TECHNICAL BULLETIN
Bell Helicopter
A Textron Company

No. 206L-09-238

MODEL AFFECTED: 206L

SUBJECT: SPANNER NUT P/N MS172242, INSPECTION OF.

Figure 1. Oil cooler blower assembly

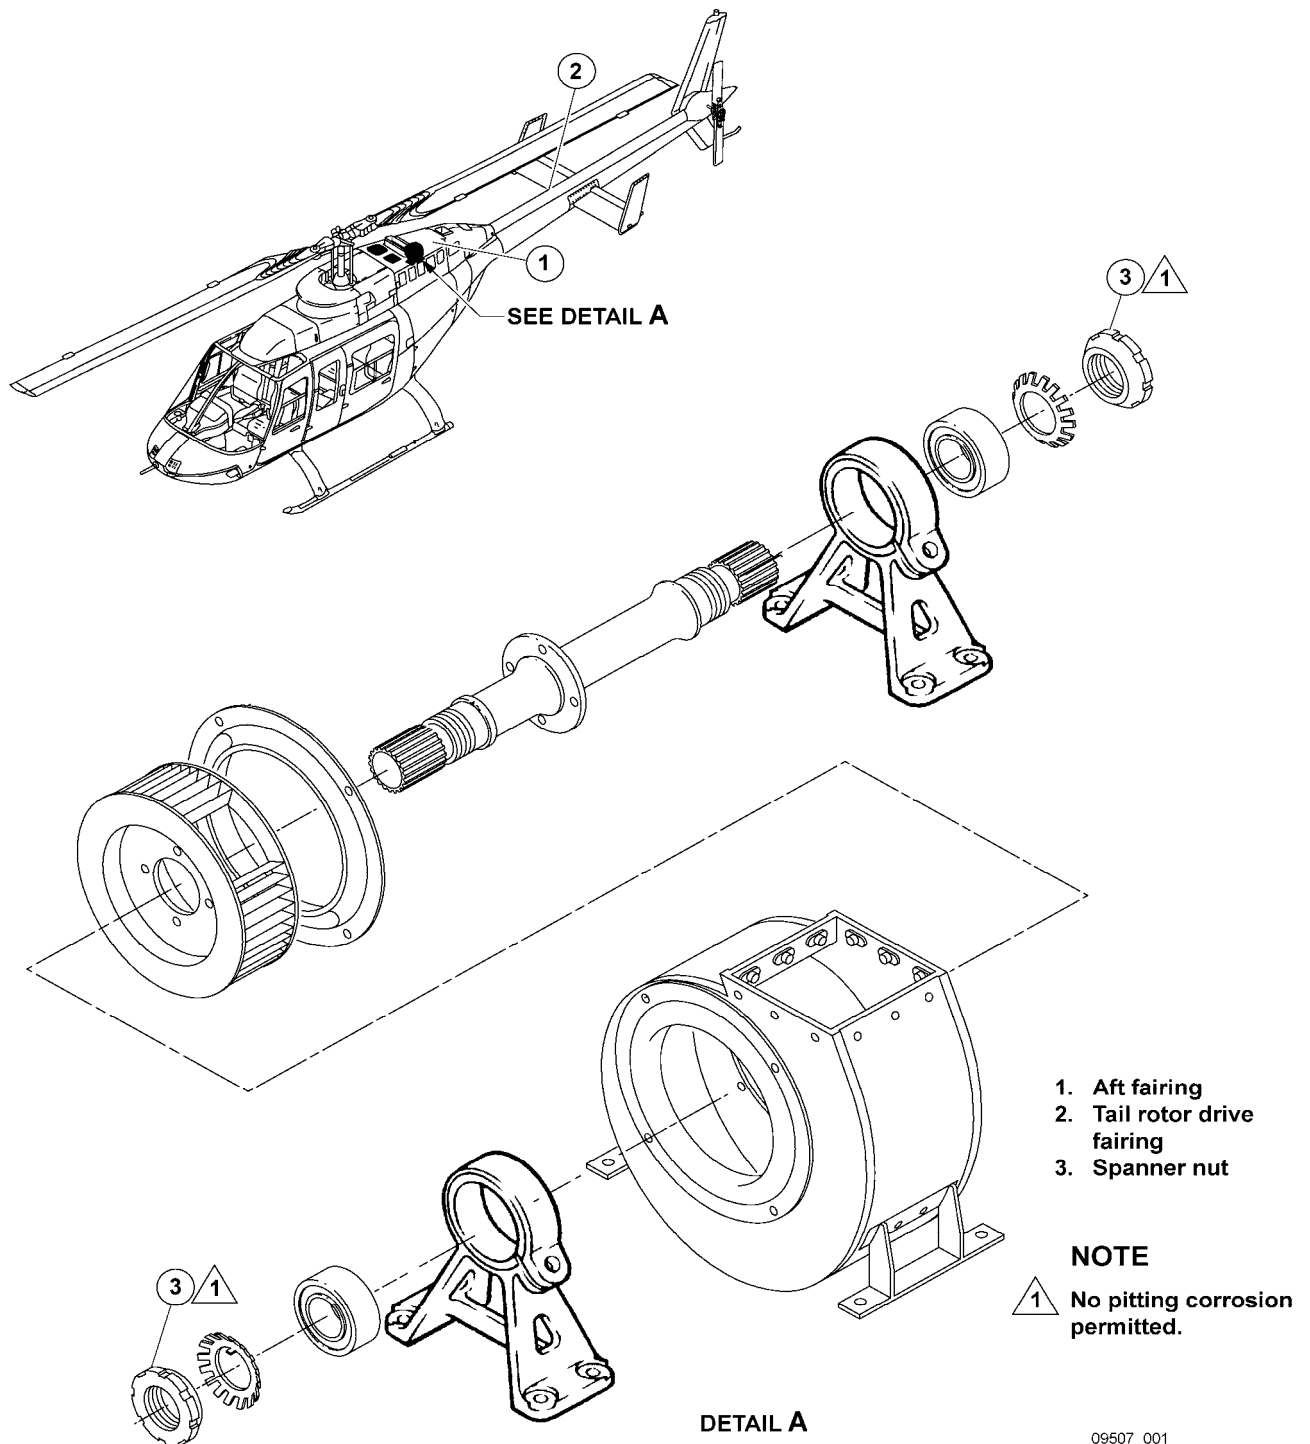
1. Gain access to oil cooler blower shaft assembly (Refer to Detail A, Fig 1).

2. Clean forward and aft nuts (3) using Aliphatic Naphtha (C-305).
3. Examine forward and aft spanner nuts (3) for evidence of corrosion.
 - a. If surface corrosion is found, remove and replace with nut 90-118-2 or phosphate coated nut MS172242 (Refer to BHT-206L-CR&O Chapter 65). If the nut can not be replaced immediately, apply corrosion preventive compound (C-101). Replace the nut when ever convenient.
 - b. If pitting corrosion is found, remove and replace immediately with nut 90-118-2 or phosphate coated nut MS172242 (Refer to BHT-206L-CR&O Chapter 65).
